From: Bratcher, Mike, EMNRD
Sent: Tuesday, November 02, 2010 1:10 PM
To: 'Bob Asher'
Subject: RE: Sample Results (Creek AL Federal #19)

CREEK AL FEDERAL #19

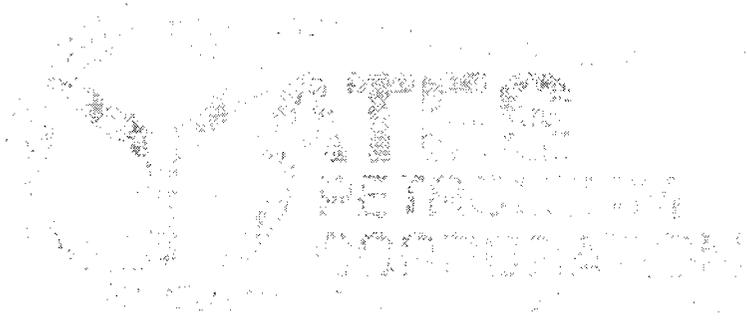
Thanks for the clarification. The only other issue I would have is that the BTEX and chloride levels both increased at final depth. The BTEX levels are below limits and the chloride level would likely be allowed to be left in place, but for delineation, and to show that the increase is limited, I would prefer to see a deeper sample taken.

I have a couple of questions:

Are these the correct sample dates?

Has any material been excavated at this site?

Sorry, the first set was taken on 9/13/2010 not October 13, 2010 and a contractor excavated approximately 2 feet on impacted soils and hauled to Lea Land on September 30, 2010. The depth of samples for the October 21, 2010 set was total below surface level. (Corrected Result Sheet)

A total of two (2) feet of impacted soils were excavate and taken to an NMOCD approved facility.
